INVITATION TO BID NO. 21-DPR-ITB-673

ADDENDUM NO. 2

Arlington County Invitation to Bid No. 21-DPR-ITB-673 for Construction of Thomas Jefferson Upper Field Turf Conversion is amended as follows:

SHEET 18 OF 42

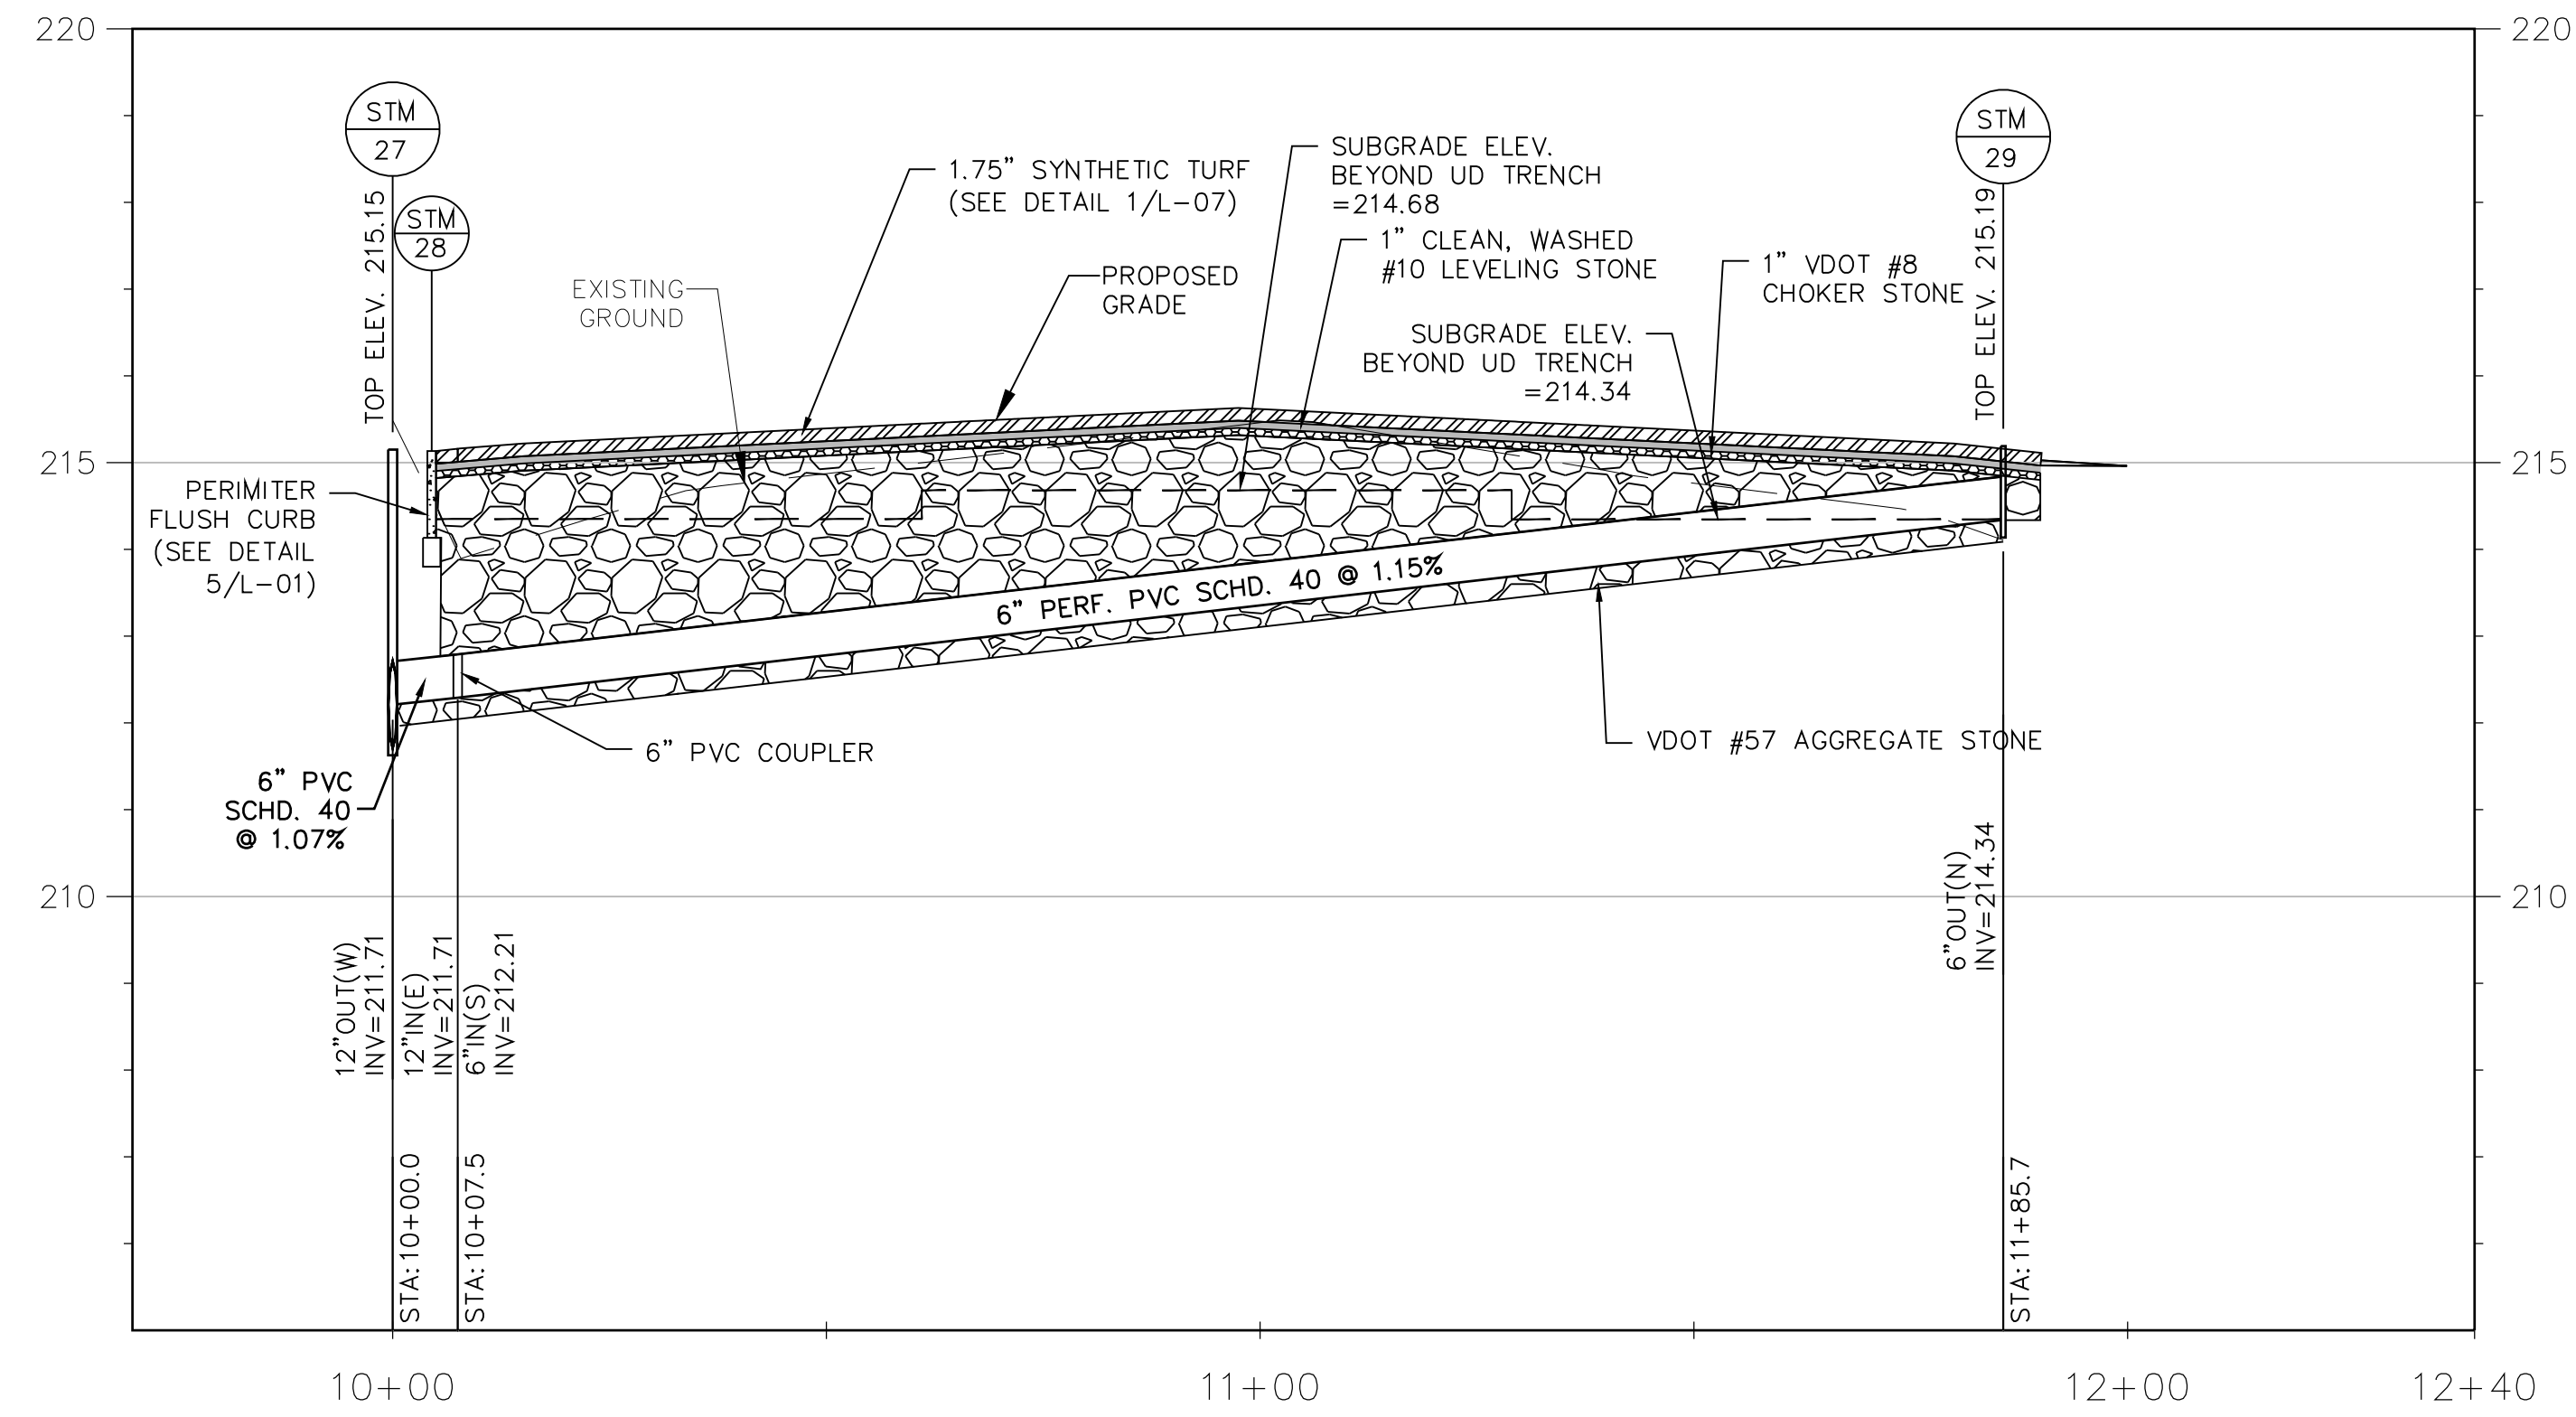
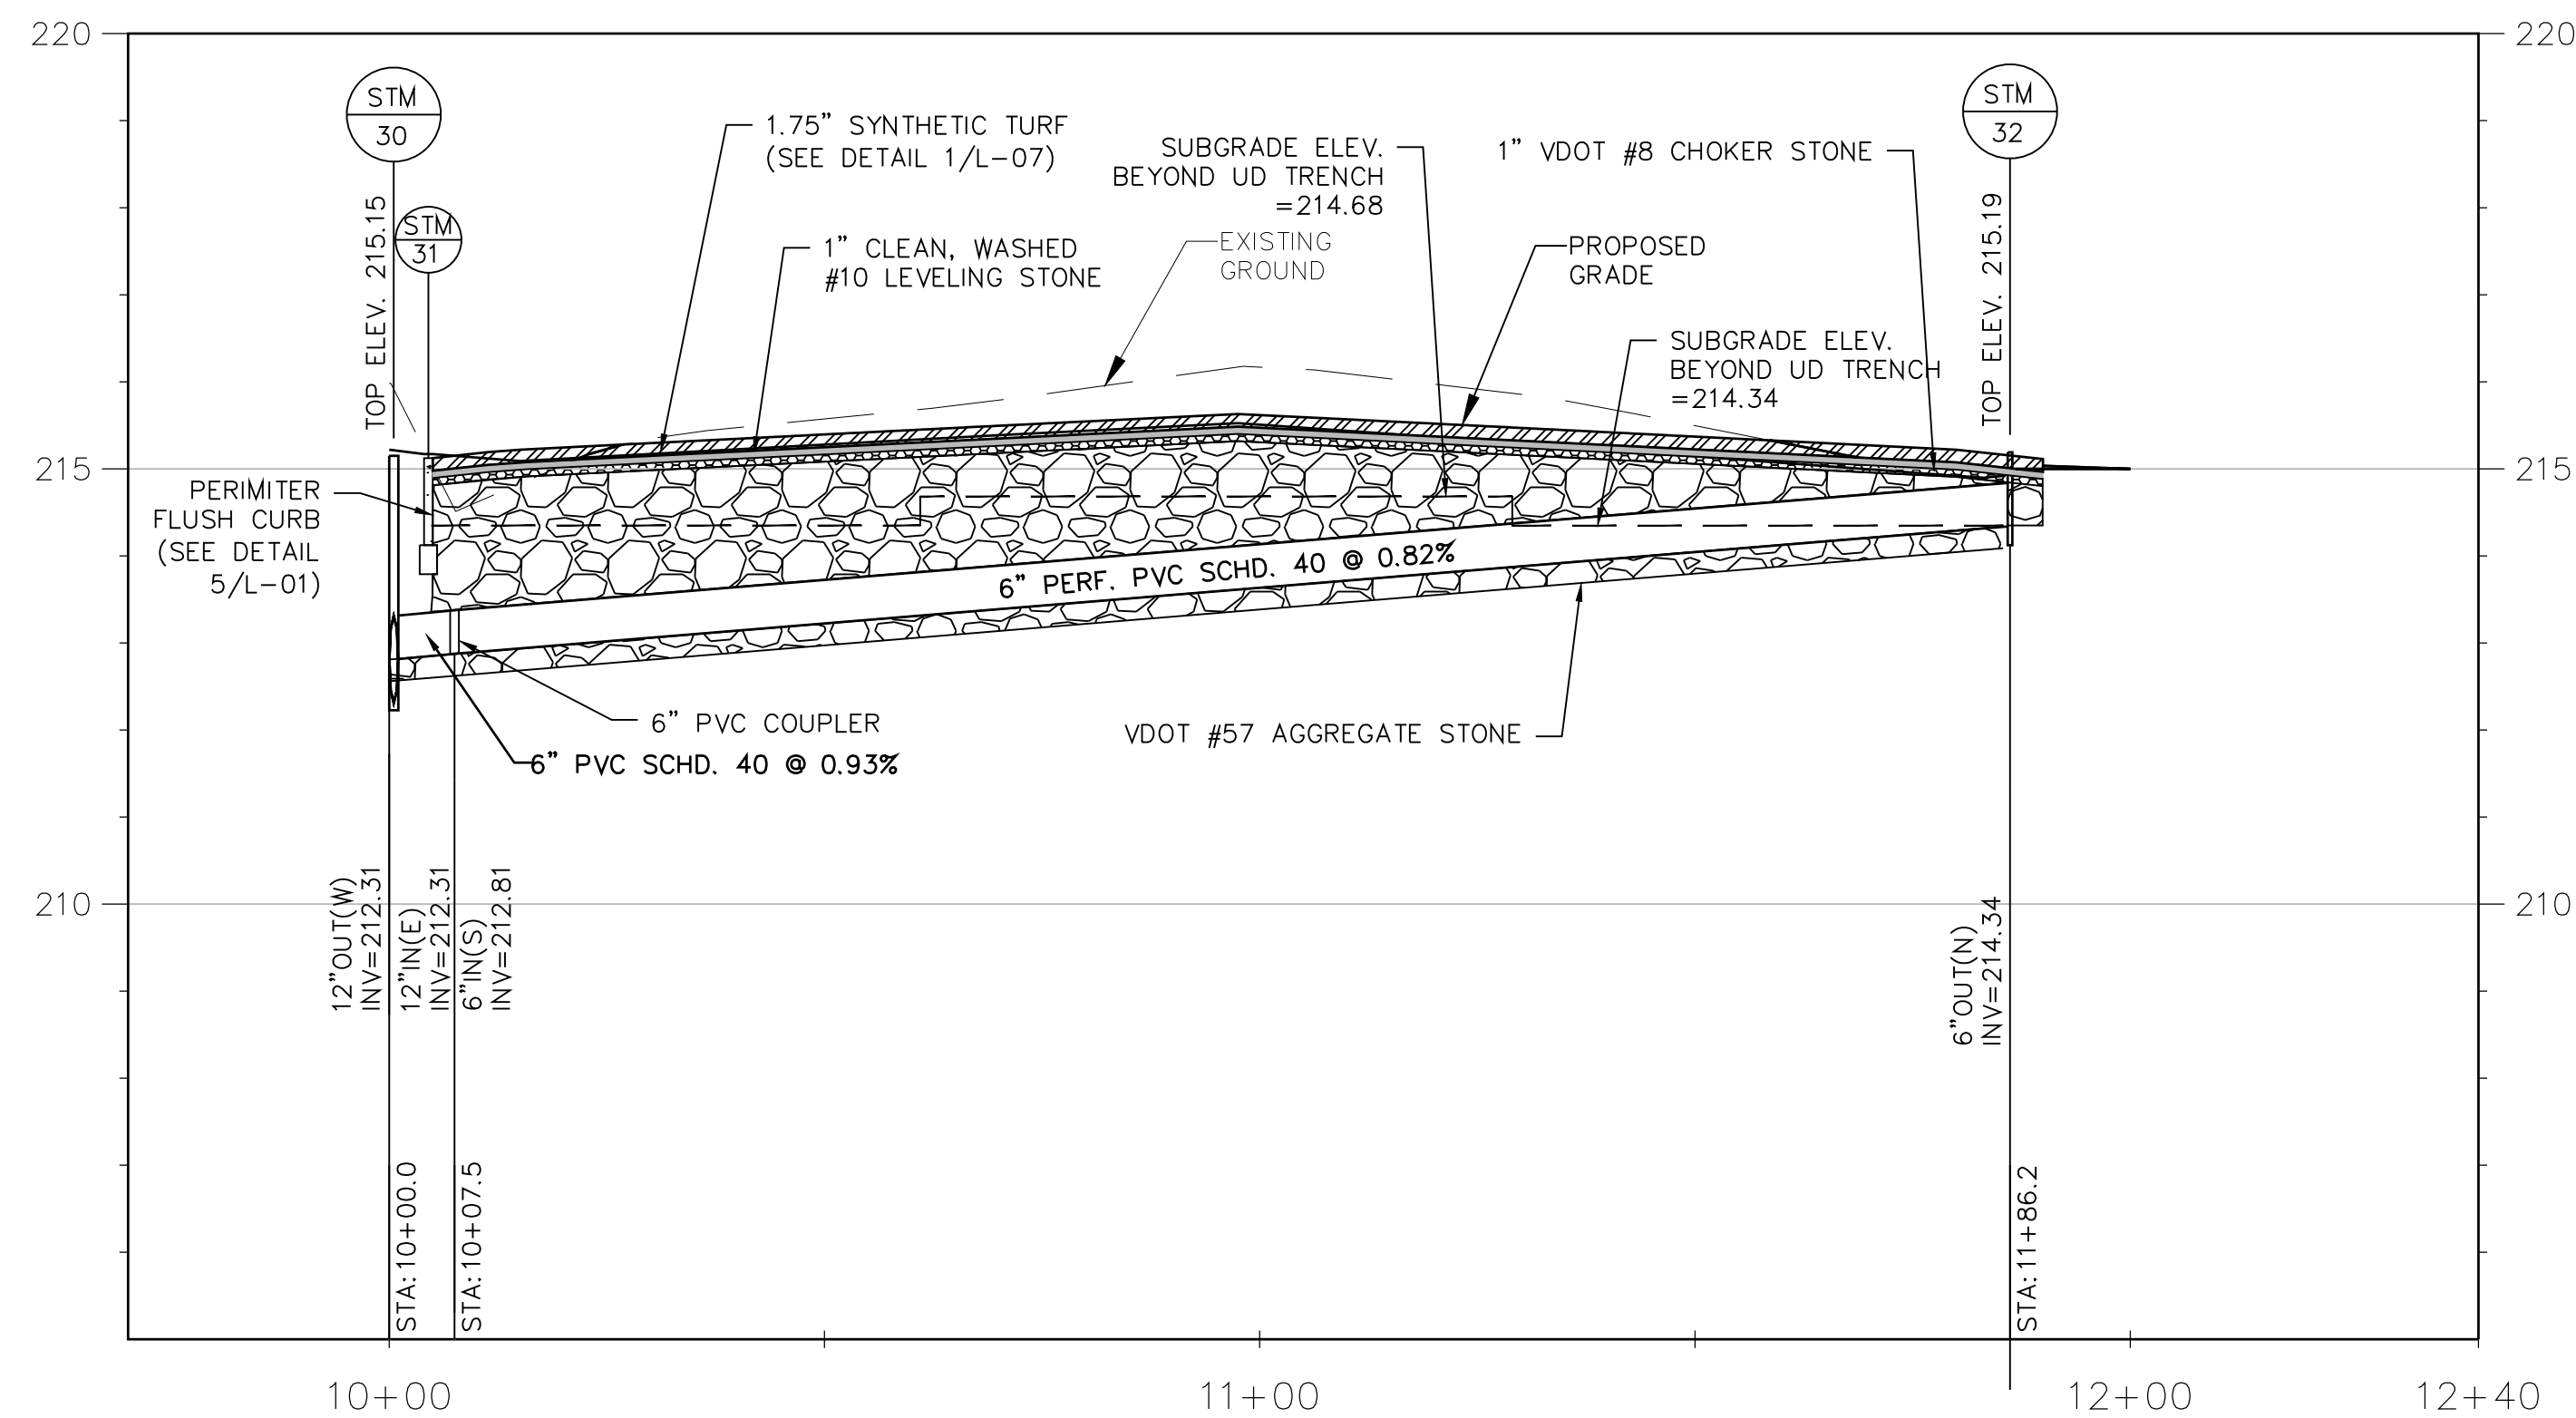
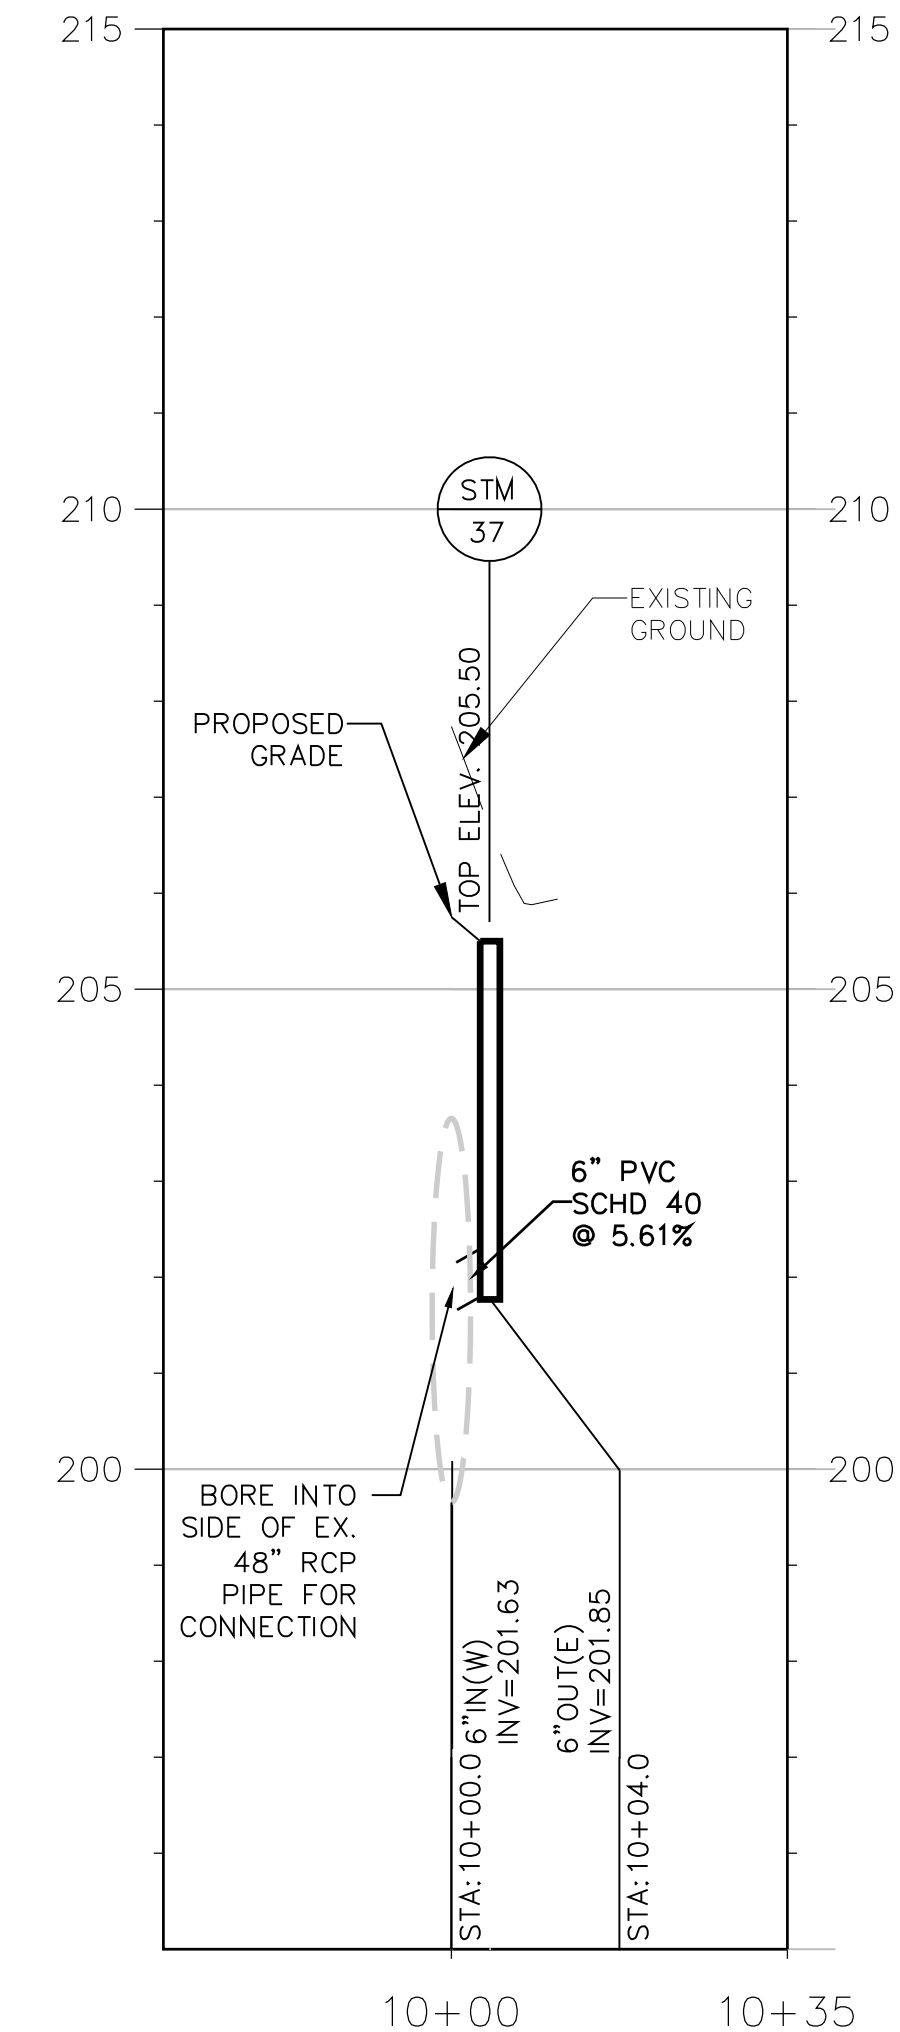
6. **Question: Drawing C15 to C15B have "???" symbols on the storm structure profile and do not identify the storm structure's locations. Please provide drawing for the storm structure profiles and locations.**

Answer: Sheets C-01, C-04, C-11, C-15, C-15A and C-15B have been revised. See attached (Attachment D - Addendum 2 Plans.pdf)
